re: Grading and Site Servicing Plans Review
Proposed Building Addition
1981 Century Road – Ottawa, Ontario
to: Brunstad Christian Church Ottawa
to: Q9 Planning – Christine McCuaig – christine@q9planning.com
date: August 24, 2026
file: PG6727-MEMO.03

The following grading and site servicing plan drawings prepared by TATHAM Engineering have been reviewed by Paterson in the preparation of the current memorandum:

- ☐ Site Grading and Servicing Plan – 1981 Century Rd. West – Burnstad Christian Church Ottawa – File No. 523654 – Drawing No. SG-1 and SG-2 – Revision 5, dated July 2026.

TATHAM ENGINEERING		
DESIGN: HY	FILE: 523654	DWG: SG-1
DRAWN: HY	DATE: SEPT 2024	
CHECK: GC	SCALE: 1:300

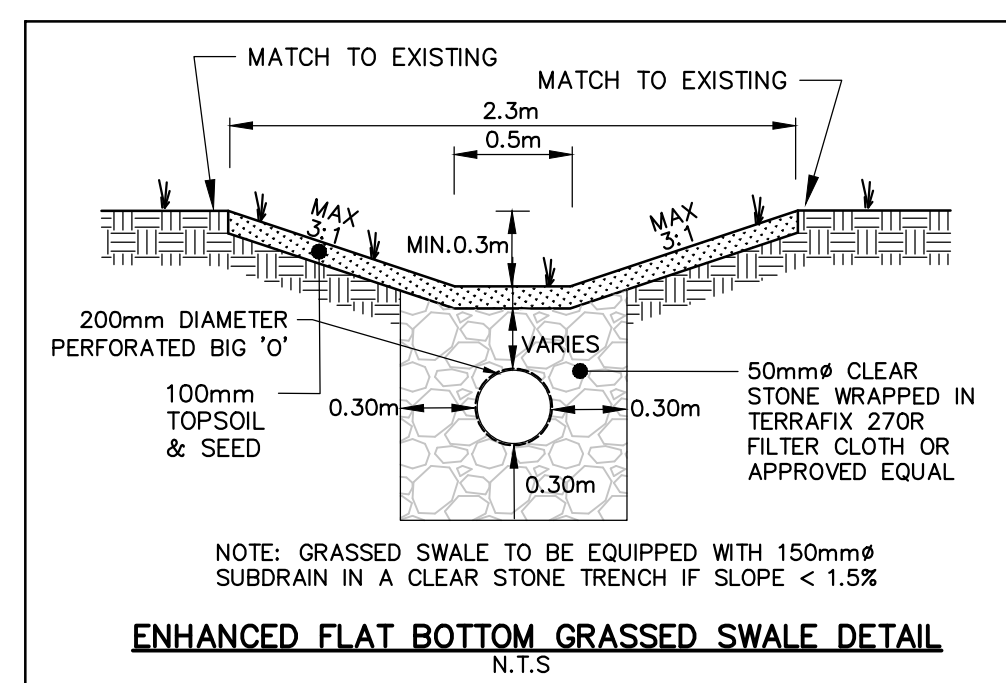
Insufficient frost protection has been provided for the proposed storm sewer pipes throughout the subject site. Reference should be made to Figures 1 and 2, including Paterson's markup on site servicing plans for the location of pipes where insulation will be required, attached to this memorandum.

In the following section, frost protection of the site servicing is recommended where insufficient frost cover has been provided. Any portion of the services installed at a depth of 2.1 m below the finished grade or deeper is considered to have sufficient soil cover for frost protection. Where insufficient soil cover is present above the invert of storm sewer pipe, the following frost protection criteria given in Table 2 should be followed.

Table 2 - Rigid Insulation Recommendations for Sanitary and Storm Sewer Pipes with Reduced Soil Cover			
Thermal Condition	Soil Cover Provided (mm)	Insulation Dimensions	
		Thickness (mm)	Extension (mm)
Unheated	600 to 900	125	Extend 1200 mm horizontally beyond edge face of the pipe
	900 to 1200	100	Extend 1200 mm horizontally beyond edge face of the pipe
	1200 to 1500	75	Extend 900 mm horizontally beyond edge face of the pipe
	1500 to 1800	50	Extend 600 mm horizontally beyond edge face of the pipe
	1800 to 2100	25	Extend 300 mm horizontally beyond edge face of the pipe
Notes: All designs are based on a freezing index of 1000°C-days

Figure 2 - markup site servicing plan for the location of pipes where insulation will be required

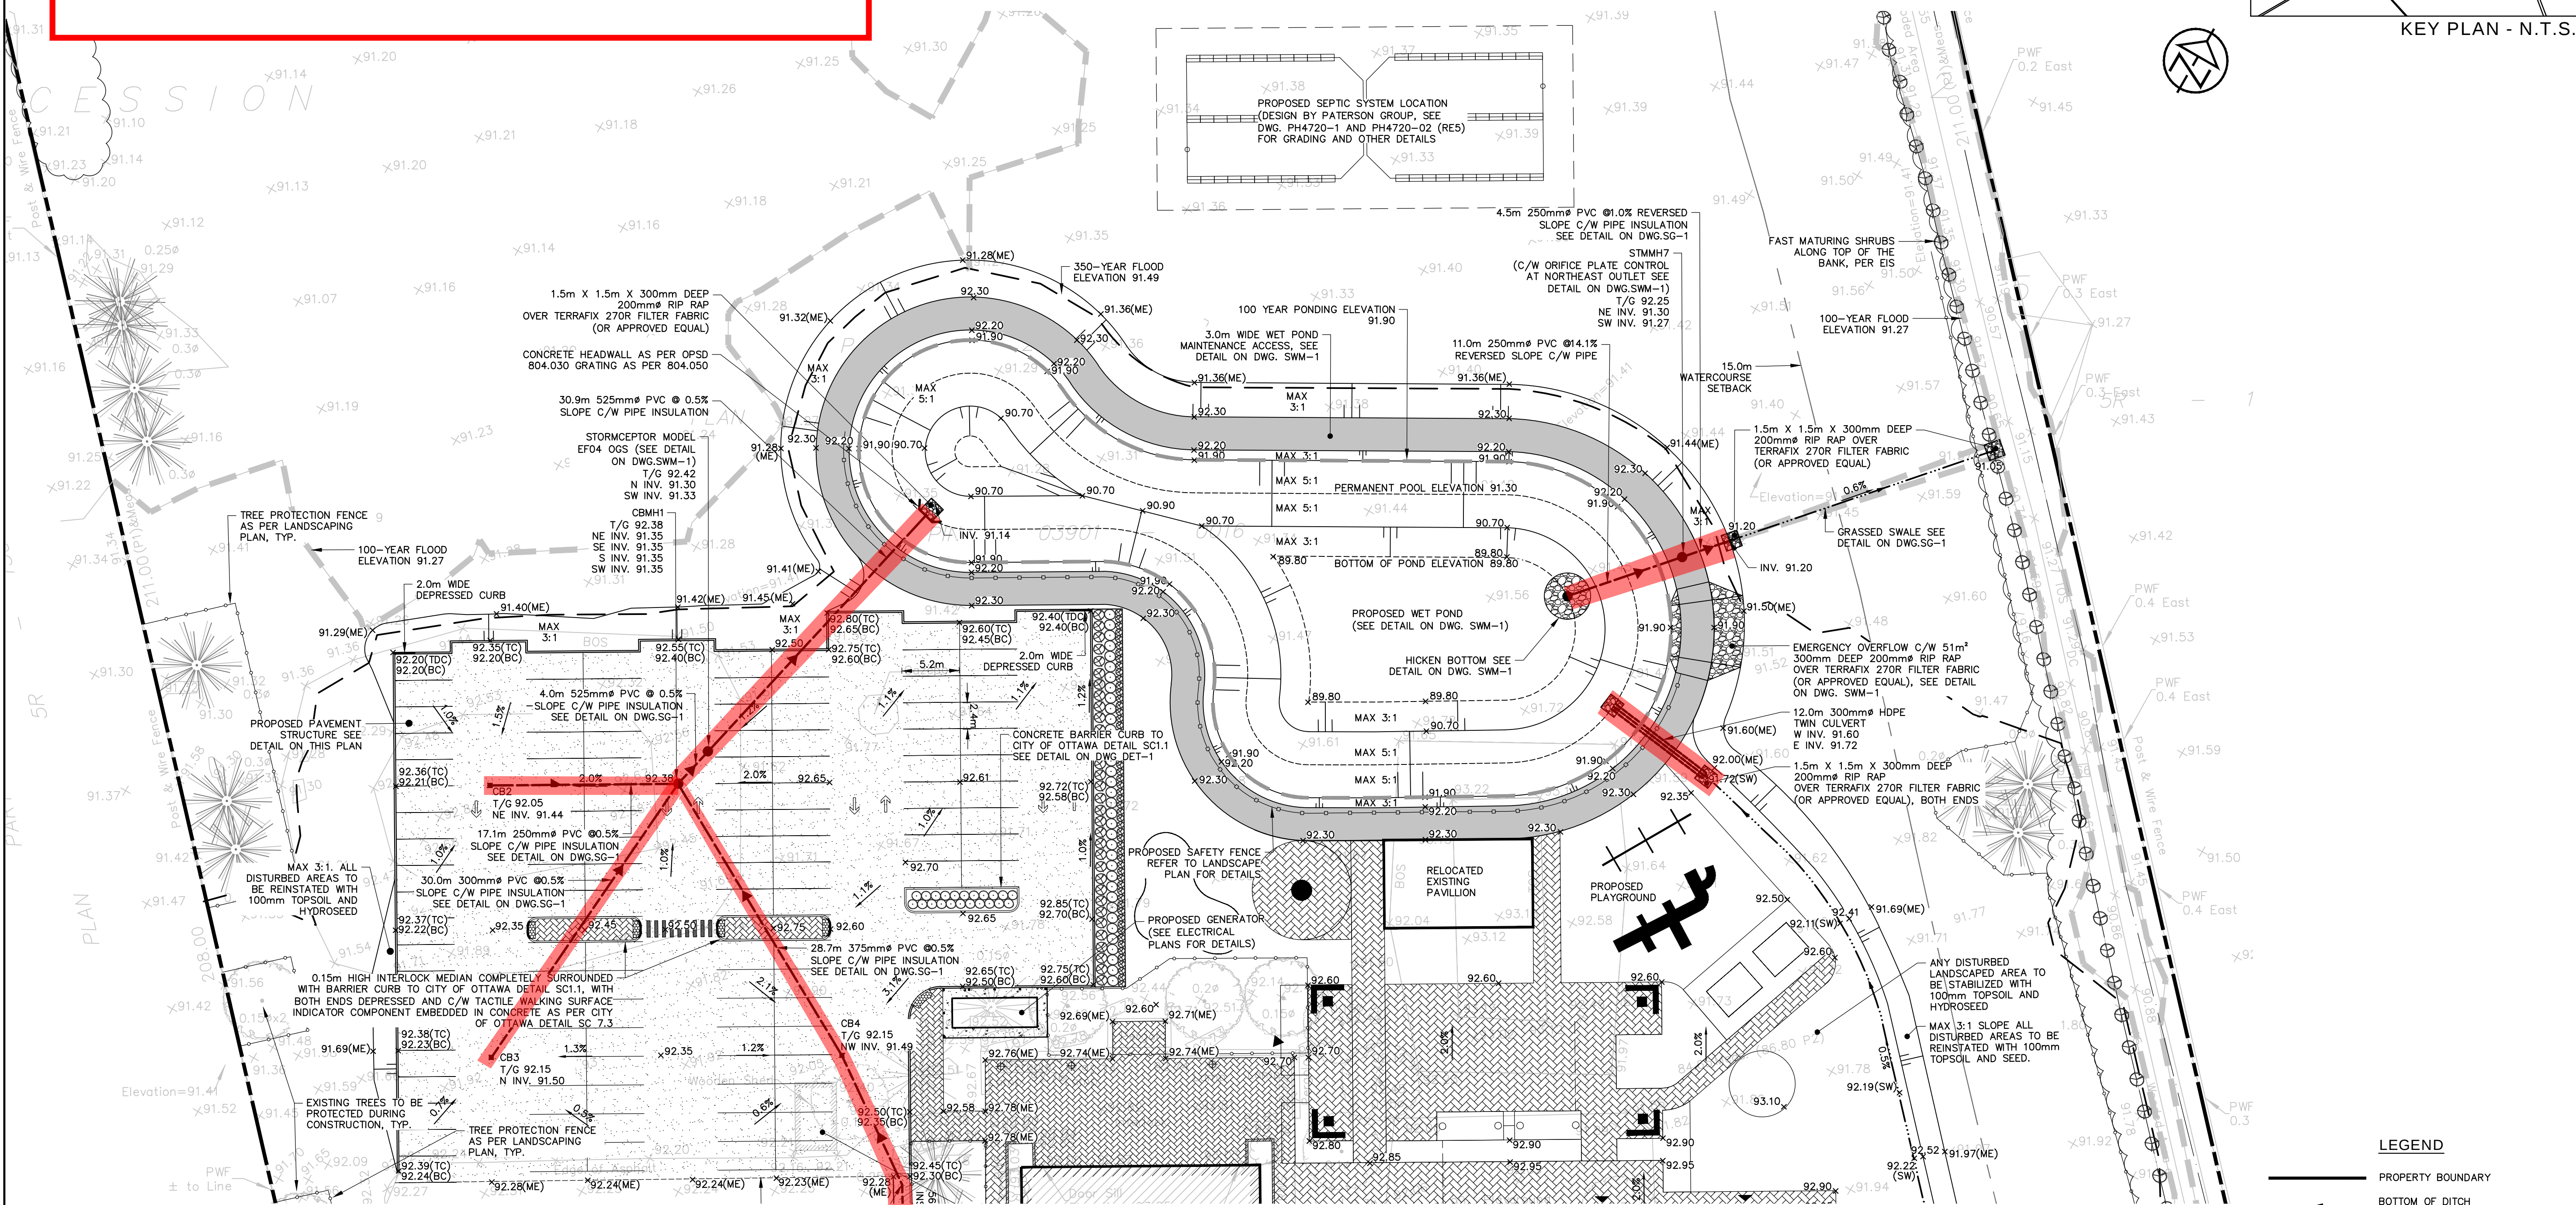
Insufficient Soil Cover for Pipes or Culverts (Less than 2.1 m)

TYPICAL FROST INSULATION DETAIL

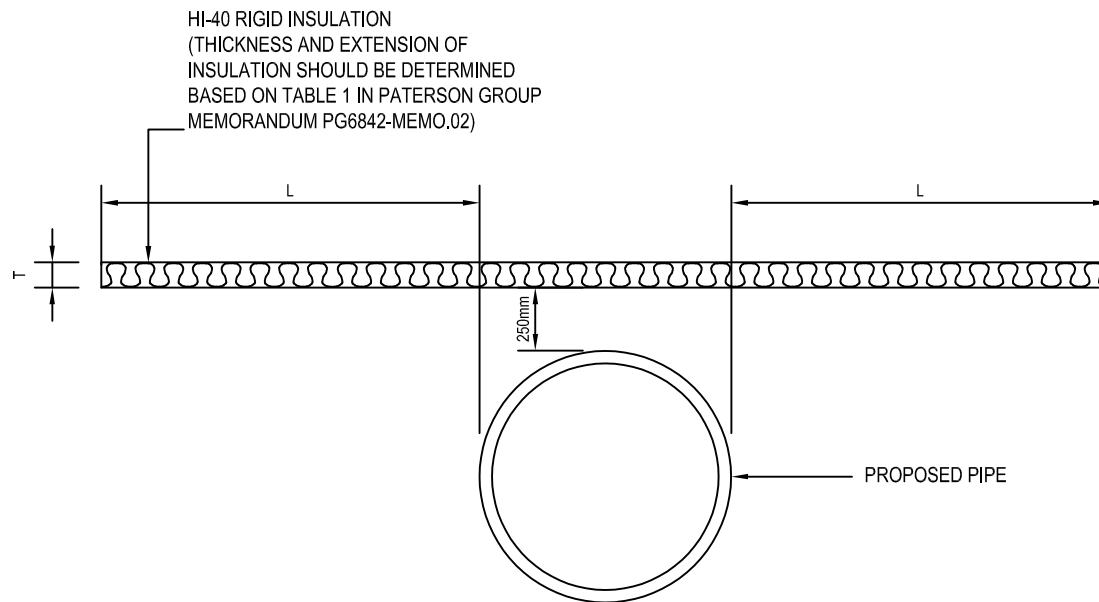
All rigid insulation should consist of either Dow Chemical High-Load 40 (HI-40), Styro Rail SR.P400, or equivalent approved by Paterson. The placement of all insulation within the service trenches must be reviewed and approved by Paterson personnel at the time of construction. Reference should be made to Figure 3 – Typical Frost Insulation Detail, attached to this memorandum.
